TURKEY POINT PLANT UNIT NO. 3

Amendment No. 80
License No. DPR-31

Amendment No. 74
License No. DPR-41

SAFETY EVAULATION BY THE OFFICE OF NUCLEAR REACTOR REGULATION

HOT CHANNEL FACTOR
NORMALIZED OPERATING ENVELOPE

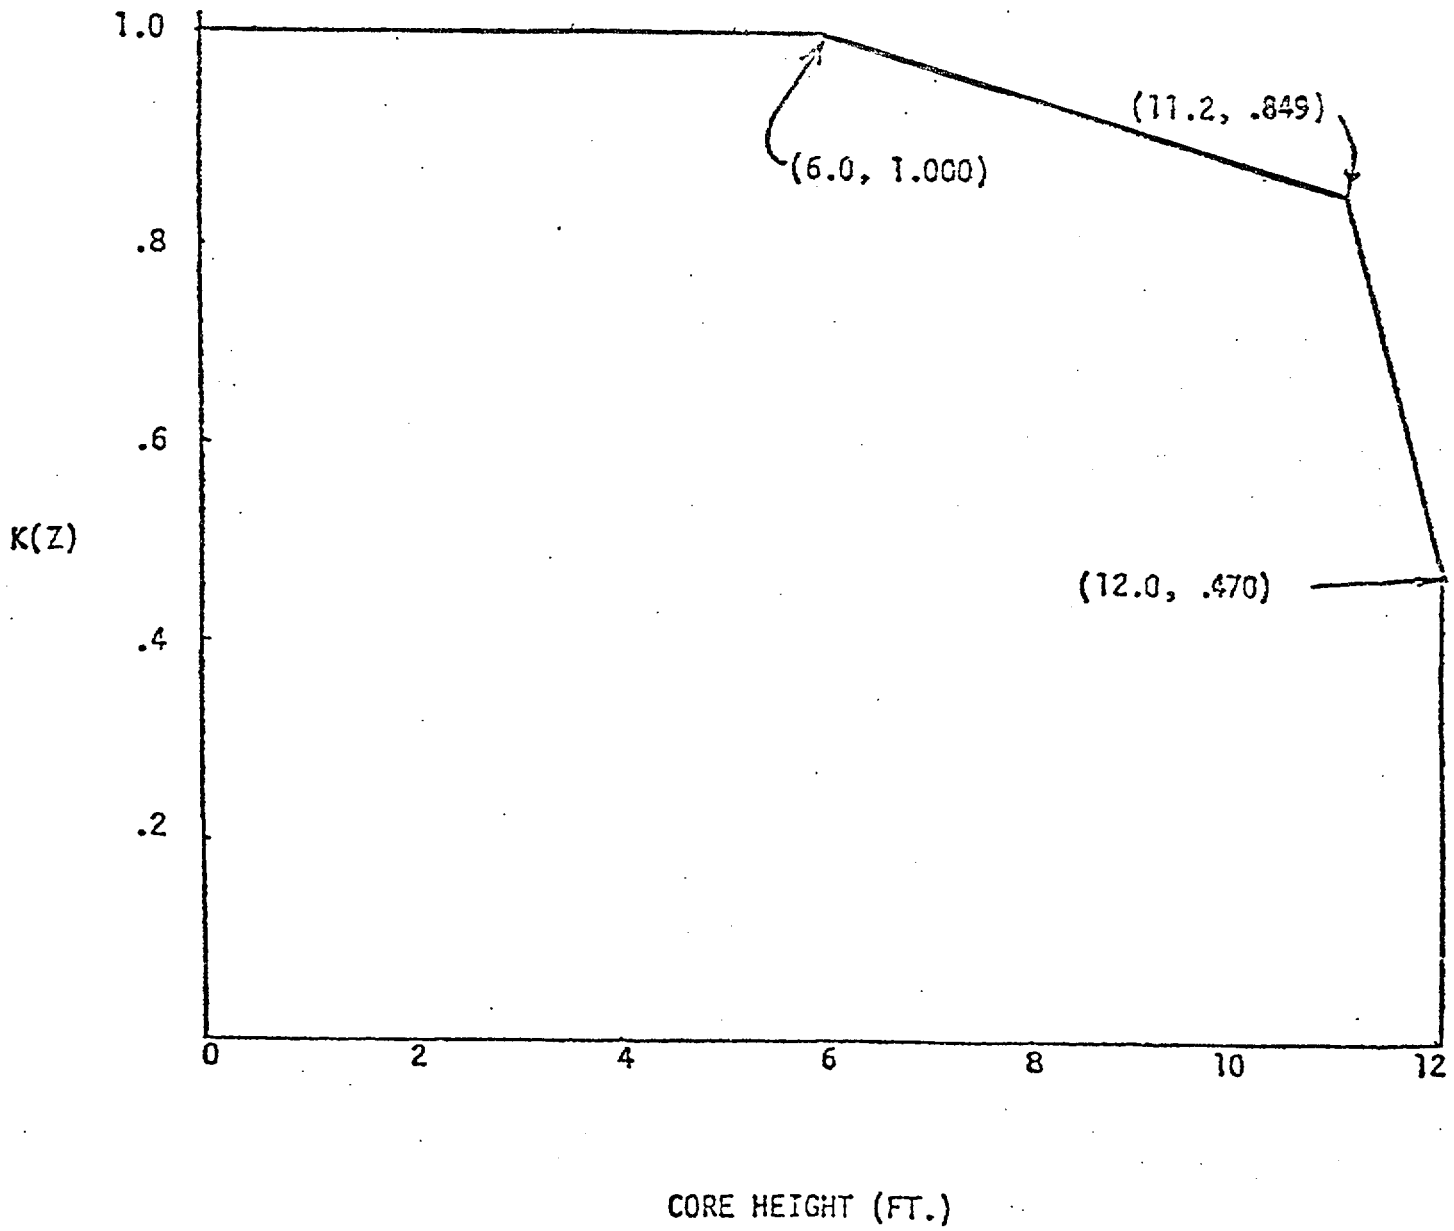
Where P is the fraction of rated power at which the core is operating; K(Z) is the function given in Figure 3.2-3; Z is the core height location of F_Q. $[F_Q]_L$ and K(Z) are dependent on the steam generator tube plugging level as follows:

Plugging level	$[F_Q]_L$	Figure Number for K(Z)
$\leq$ 28%	2.125	3.2-3

An upper bound envelope as defined by normalized peaking factor axial dependence of Figure 3.2-3, has been determined to be consistent with the technical specifications on power distribution control as given in Section 3.2.

The technical specifications on power distribution control assures that the $[F_Q]_L$ upper bound envelope as defined by Figure 3.2-3, is not exceeded and xenon distributions are not developed which at a later time would cause greater local power peaking even though flux difference is then within the limits specified by the procedure.
